**FORD:**

2013-2014 Escape

**ISSUE**

Figure 1 - Article 14-0004

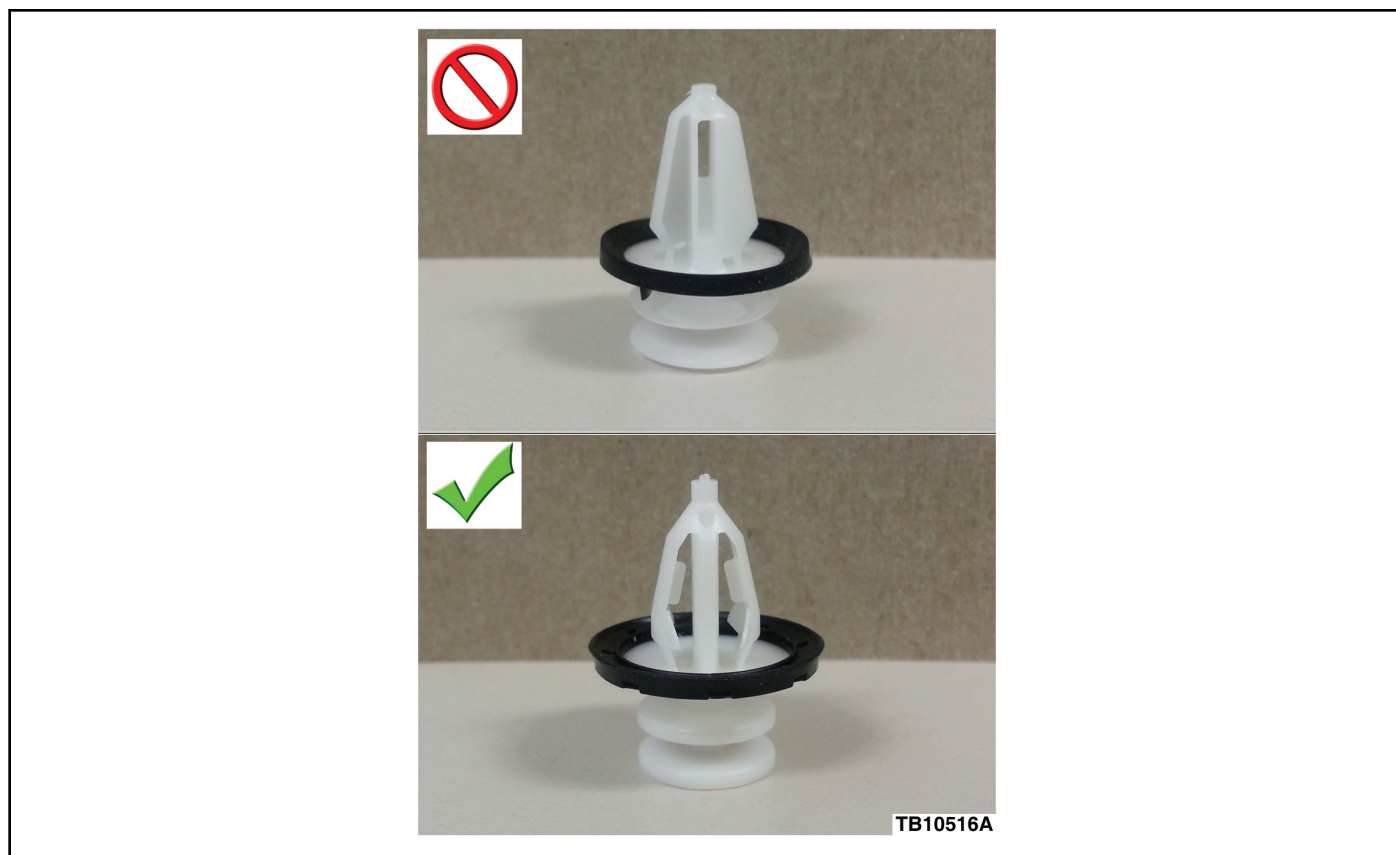
Some 2013-2014 Escape vehicles built on or before 9/13/2013 may exhibit loose attachment of the left or right rear door trim panel, typically near the bottom of the door. A new retaining clip is now available for service.

1. Is the affected rear door trim panel damaged as a result of the loose attachment?
  - a. Yes - replace the rear door trim panel. Refer to Workshop Manual (WSM), Section 501-05. Use new style retaining clips on new door panel. (Figure 1) Repair is complete.

- b. No - proceed to Step 2.
2. Remove the affected rear door trim panel. Refer to WSM, Section 501-05.
3. Remove the seven retaining clips from the rear door trim panel and discard.

4. Install the new retaining clips into the holes in the door trim panel.
  - a. When retaining clip is inserted in the correct position a clicking noise can be heard.
5. Install the rear door trim panel. Refer to WSM, Section 501-05.
